Project	IEEE 802.16 Broadband Wireless Access Working Group < <a href="http://ieee802.org/16">http://ieee802.org/16</a> >	
Title	<b>Overview of the proposal for MS MAC handover procedure in an MR Network</b>	
Date Submitted	2007-01-16	
Source(s)	Hyunjeong Lee <a href="mailto:Hyunjeong.hannah.lee@intel.com">Hyunjeong.hannah.lee@intel.com</a> Wendy C. Wong, Jerry Sydir, Kerstin Johnsson Intel Corporation 2111 NE 25 <sup>th</sup> Ave Hillsboro, OR 97124  Sujean Yang <a href="mailto:sujean35@ewhain.net">sujean35@ewhain.net</a> Meejeong Lee <a href="mailto:lmj@ewha.ac.kr">lmj@ewha.ac.kr</a> Dept. of Computer Science and Engineering Ewha Womans University, Seoul, Korea  <a href="mailto:Yanling.Lu@hisilicon.com">Yanling Lu</a> <a href="mailto:luyanling@hisilicon.com">luyanling@hisilicon.com</a> <a href="mailto:Ting.Li@hisilicon.com">Ting Li</a> <a href="http://www.hisilicon.com">Hisilicon Technologies</a> Harbour Building, No.8, Dongbeiwang West Road, HaiDian District, Beijing, China	Hyunjeong Kang <a href="mailto:Hyunjeong.kang@samsung.com">Hyunjeong.kang@samsung.com</a> Sungjin Lee, Hyoung Kyu Lim, Jungje S Samsung Electronics 416, Maetan-3dong, Youngtong-gu, Suwon-si, Gyeonggi-do, Kore

Figure xx Seven Handover Cases in MR networks

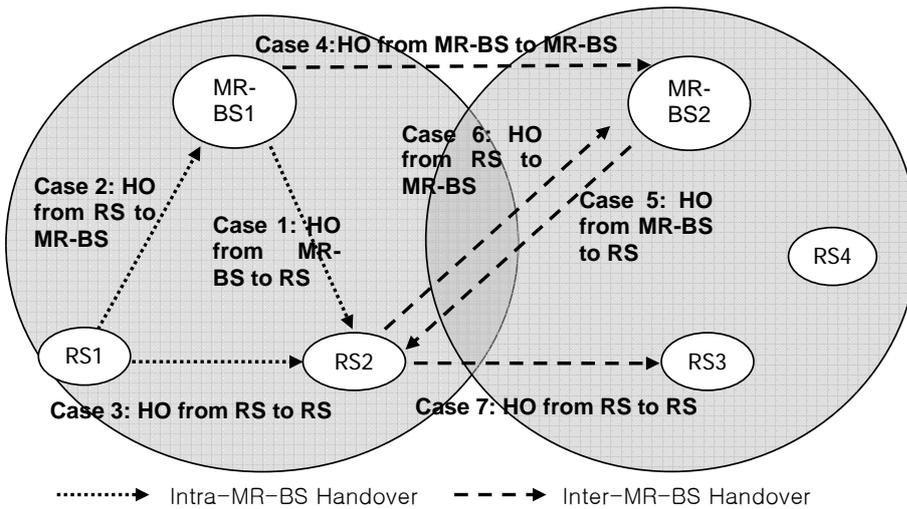
*[Insert the following in subclause 6.3.22 before subclause 6.3.22.1]*

Considering a multi-hop relay (MR) network with non-transparent fixed or nomadic RSs, seven different handover cases illustrated in Figure 1 can occur in an MR network. The seven cases belong to two main categories of handover: (1) Intra MR-BS handover if the handover is between two RSs controlled by the same MR-BS or between an MR-BS and one of its subordinate RSs; and (2) Inter MR-BS handover if the handover is between two MR-BSs, two RSs each controlled by different MR-BSs, or between an MR-BS and an RS controlled by a different MR-BS.

There are only two infrastructure stations involved with an MS handover for Cases 1, 2, and 4.

On the other hand, there are three infrastructure stations involved for Cases 3, 5, and 6: (1) Case 3: RS1 is the current access station, RS2 is the target access station, and MR-BS1 is the serving station. MR-BS1 remains as the serving station after the handover. (2) Case 5 - MR-BS2 is the current serving and access station, RS2 is the target access station, and MR-BS1 is the target serving station (3) Case 6- MR-BS1 is the current serving MR-BS, RS2 is the current access station, and MR-BS2 is the target serving and access station. Finally, there are four stations involved for Case 7: MR-BS1 is the current serving station, RS2 is the current access station, MR-BS2 is the target serving station and RS3 is the target access station.

A handover between a BS and an RS or MR-BS can be covered by the cases shown in Figure 1. That is, the procedure for an MS handovers between an MR-BS and a BS is identical to the one for Case 4, the procedure for an MS handover from a BS to an RS, the procedure identical to the one for Case 5, and the procedure for an MS handovers from an RS to a BS identical to the one for Case 6.

The MR network can have centralized or distributed control planes. In a distributed MR network, an RS may have a capability of authentication on management messages from/to MS. The handover procedures for these cases shall accommodate various types of RSs in a centralized or distributed MR network. Some access RSs may transparently relay handover signaling between MS and MR-BS, and others may process handover signaling. The capability of MS handover signal processing is negotiated through initial network entry of RS.
